UNITED STATES PATENT AND TRADEMARK OFFICE

APPLICATION NO.	FILING DATE	FIRST NAMED INVENTOR	ATTORNEY DOCKET NO.	CONFIRMATION NO.
09/940,103	08/27/2001	Thomas P. Glenn	G0057	4280

Office Action Summary

DETAILED ACTION

FIG. 2
MULT. CHANNEL
TRANS. DEVICE

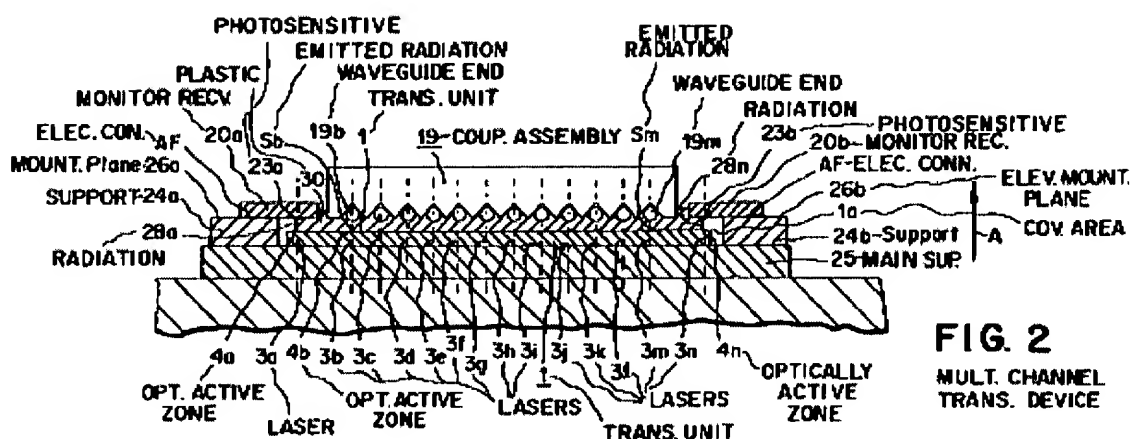
4. Claims 1-44 are rejected under 35 U.S.C. 102(b) as being anticipated by Staudemeyer et al (WO 99/29000, whose English-language equivalent Staudemeyer et al (6,612,757 B1) will be referred to hereinafter). Staudemeyer et al discloses the claimed invention. Note figure 2 which illustrates a substrate (support 24a, 24b, 25)

comprising a pocket, an electronic component (3a-3n) comprising an active area (3b-3m) and an active calibration area (3a, 3n); and a sensor (20a, 20b) coupled to the substrate (support 24a, 24b, 25), the sensor (20a, 20b) comprising a sensor area aligned with the active calibration area (3a, 3n). Note further the window (30) coupled to the substrate, the active calibration area (3a, 3n) being positioned adjacent to the first surface of the window directly opposite a position of the sensor area (20a, 20b) adjacent a second surface of the window (30).
